Comparison Report

OLD 3FM00403510 CONN.M (3961-04,TOP,3.96mm,EVER)	NEW 3FM00403530 CONN.M (M3962-4AC-A,TOP,3.96mm,XINYA)

1. Pin Header Package Dimension

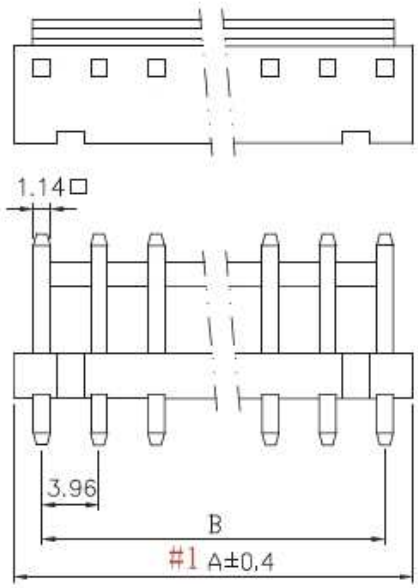
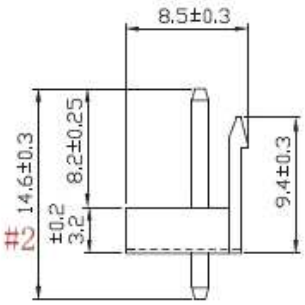
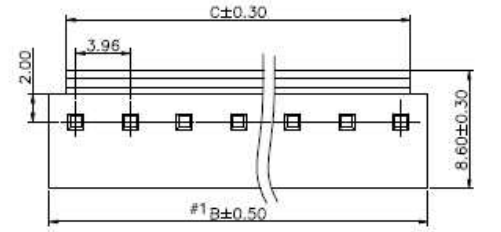
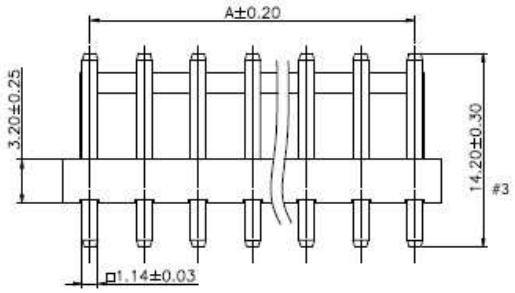
PART NO.	A	B	缺口數
3961-02	7.92	3.96	1
3961-03	11.92	7.92	1
3961-04	15.84	11.88	2
3961-05	19.84	15.84	2

No. of Contacts	DIMENSIONS		
	A	B	C
2	3.96	7.92	5.34
3	7.92	11.88	9.30
4	11.88	15.84	13.26
5	15.85	19.80	17.22
6	19.80	23.76	21.18
7	23.76	27.72	25.14
8	27.72	31.68	29.10

2. PICTURES

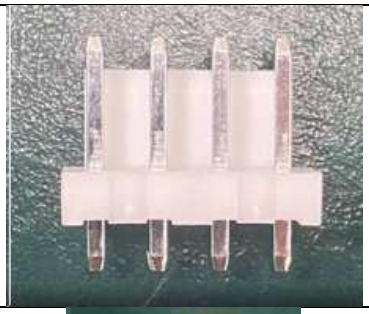
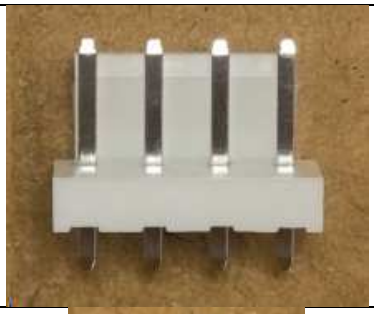
Item	OLD Part	NEW Part
Front View
